SERVICE BULLETIN

M-1199

2006 DYNA BATTERY CADDY BOLT RECALL

Figure 1. Battery Tray Assembly Bolt

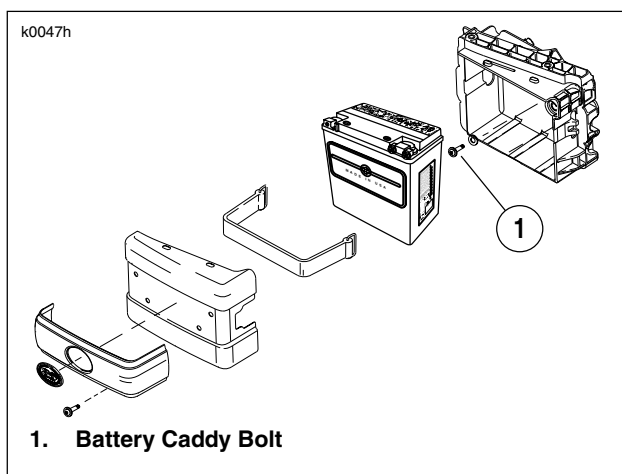
Harley-Davidson has determined that a defect relating to motor vehicle safety exists on certain model year Dyna motorcycles, built from June 17, 2005 to February 6, 2006. These vehicles contain a battery caddy bolt (Part No. 4763), which may loosen under normal riding conditions. Should this occur, the bolt can back out which allows the battery to shift position and then hold the battery in a position which may allow the battery terminals to contact the metal battery caddy cover and abrade through the positive terminal protective boot. If this occurs, the battery can short against the cover, causing sparks and possibly a fire, which could cause an accident leading to injury or death.

1. Disconnect and remove battery. See BATTERY MAINTENANCE in appropriate Dyna service manual.
2. See Figure 1. Remove and discard bolt from battery tray.
3. Obtain **new** bolt (Part No. 4613) from recall kit 94505 and install. Tighten bolt to 96-120 **in-lbs** (10.8-13.6 Nm).
4. Install remainder of battery components. See BATTERY MAINTENANCE in appropriate Dyna service manual.
5. Discard original part (Part No. 4763) removed from battery tray.
